DRAINAGE INFORMATION SHEET

PROJECT TITLE: AFD #5 ZONE ATLAS/DRNG.FILE #: K-19/D86

RE: DRAINAGE PLAN FOR ADDITION TO ALBUQUERQUE FIRE DEPARTMENT #5
(K-19/D86) ENGINEER'S STAMP DATED FEBRUARY 1, 1988

GRADING AND DRAINAGE PLAN

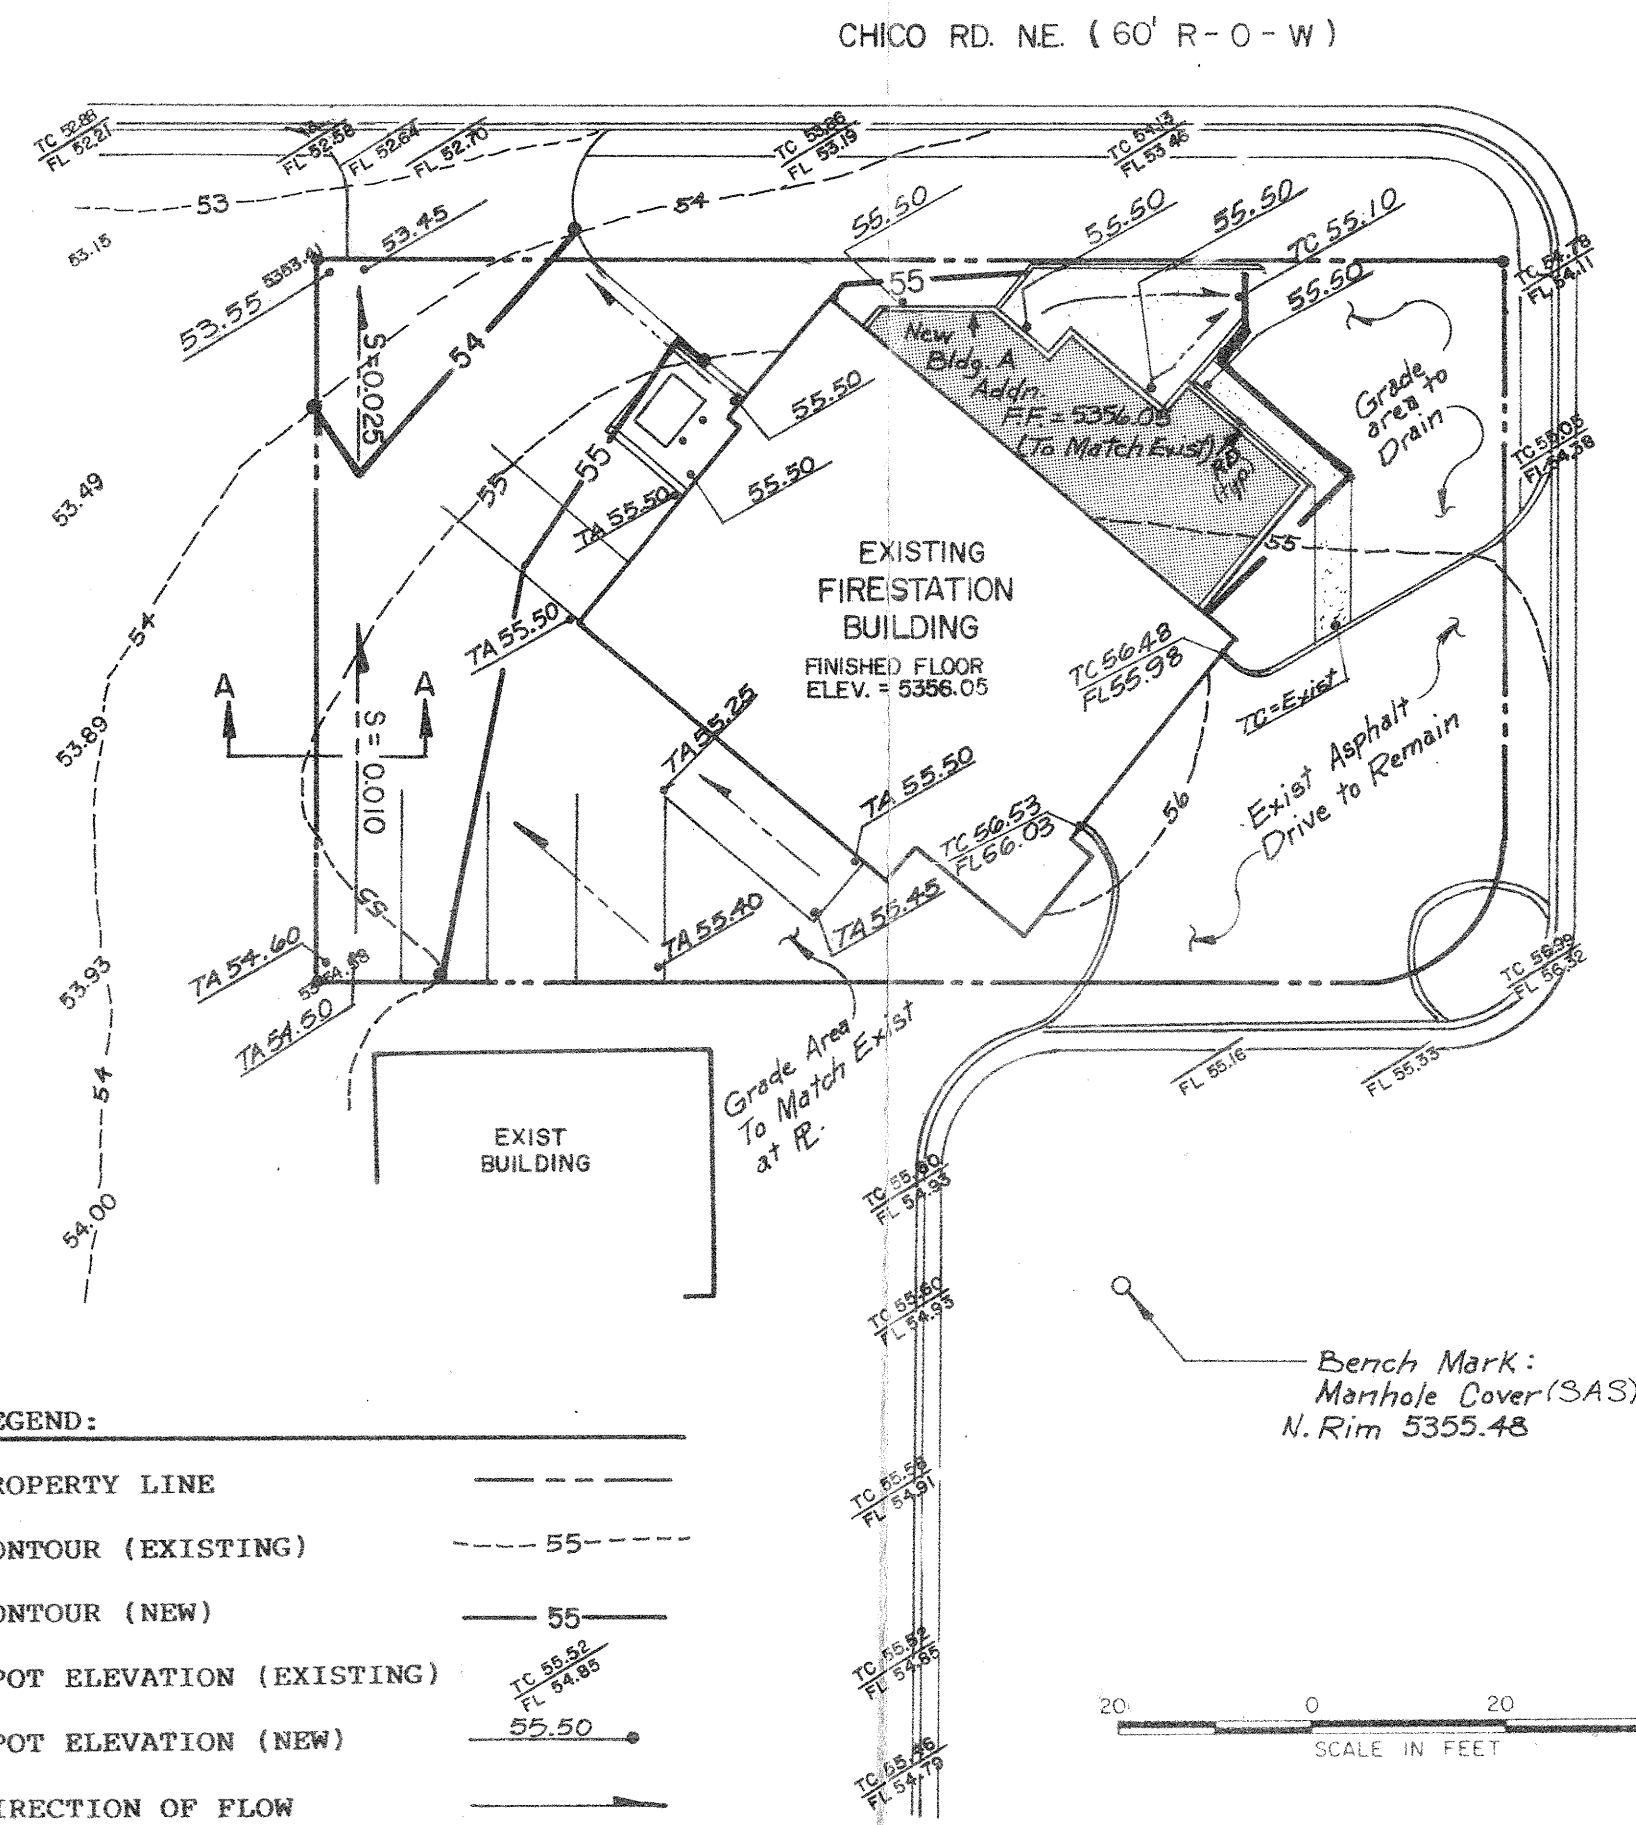
Based on the information provided on your submittal of February 3, 1988,
the above referenced plan is approved for Building Permit.

Please attach a copy of this plan to the construction sets prior to
sign-off by Hydrology.
